Package Representation Fine-Tuning

PKG Transmission Line Passivity

The suggested remedy for Comment #69: Replace the coefficients in Table 93A–2—“Transmission line model parameters”

A Minuscule Impact on COM Result

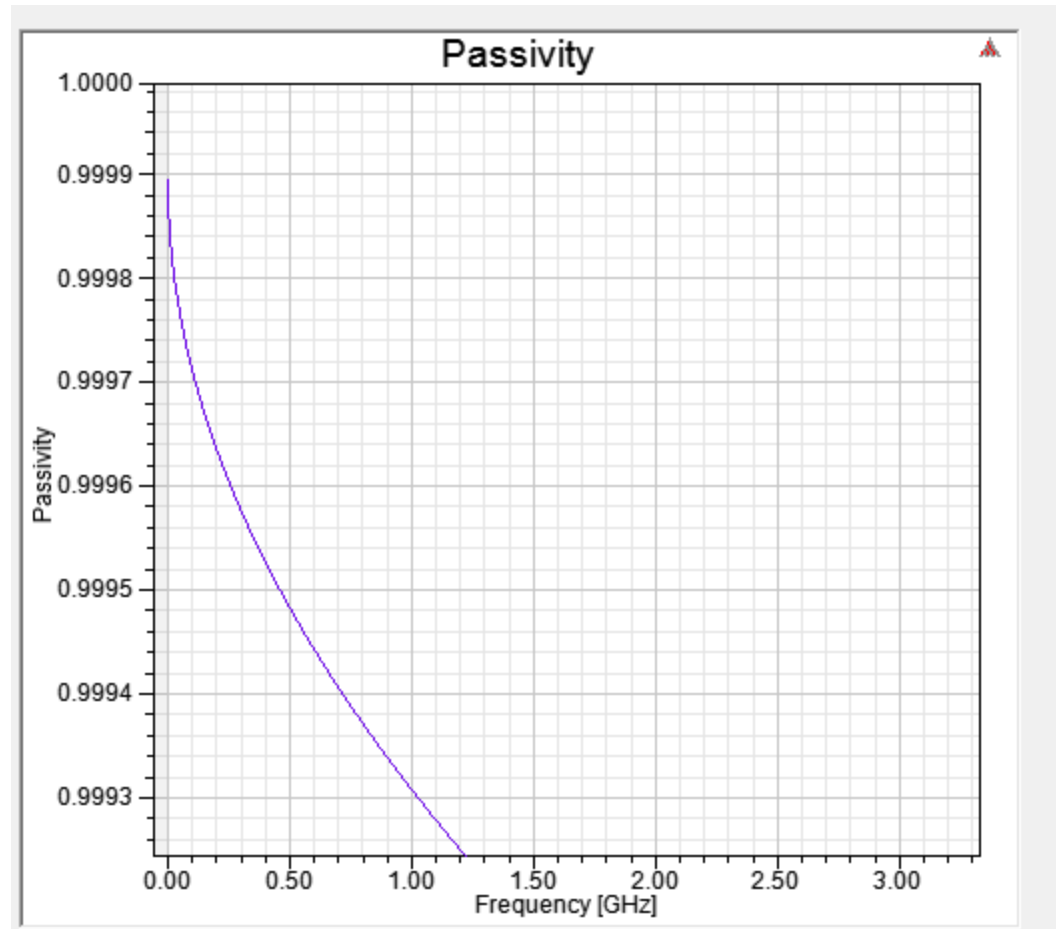
Clause 93a package transmission line representation in draft D2.1 is very slightly non-passive.

gamma complex([-1.067e-03 -3.551e-04 -1.027e-03 0.000 -1.179e-05], [0.000 -3.357e-03 -3.818e-02 0.000 3.360e-05])
rho complex([1.001e-03 -8.004e-18 -3.233e-04 3.228e-20 1.721e-07] , [0.000 -8.120e-03 -3.349e-18 7.435e-06 8.747e-21])

100GBase-CR4 Cross-talk Assumptions (Comment #77)

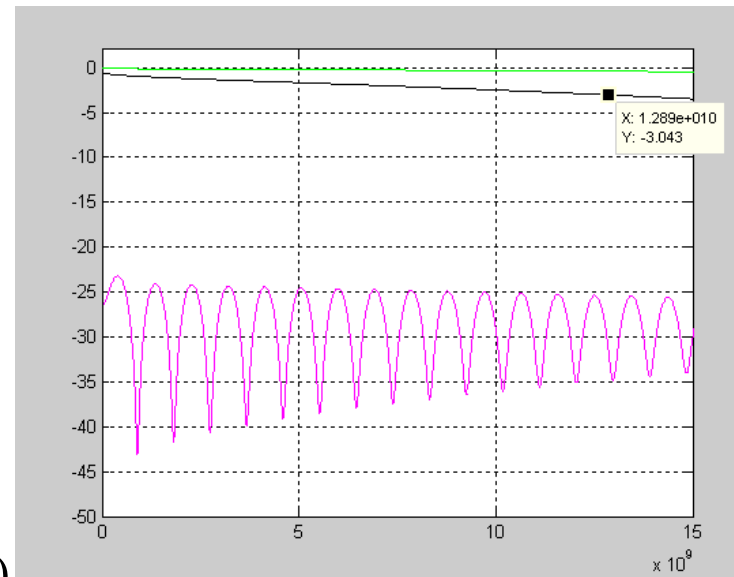
- In Draft 2.1 a CR4 host board representation was adopted according to dudek_3bj_02a_0513 and benartsi_3bj_02_0513
- A host board insertion loss of 6.26dB @ 12.89GHz was used.
- Examining the different paths of the signal it is evident that the high amount of loss is not the worst case for crosstalk impact paths, that may be routed with lower loss.
- Propose:
 - Add 6.26dB (185mm) as the Tx and Rx host board representation of the thru signal path channel, no change to D2.1 thru path implementation.
 - For NEXT and FEXT channels: add 6.26dB to Rx Host board side and 3dB (90mm) to Tx side of channel (editorial license granted)
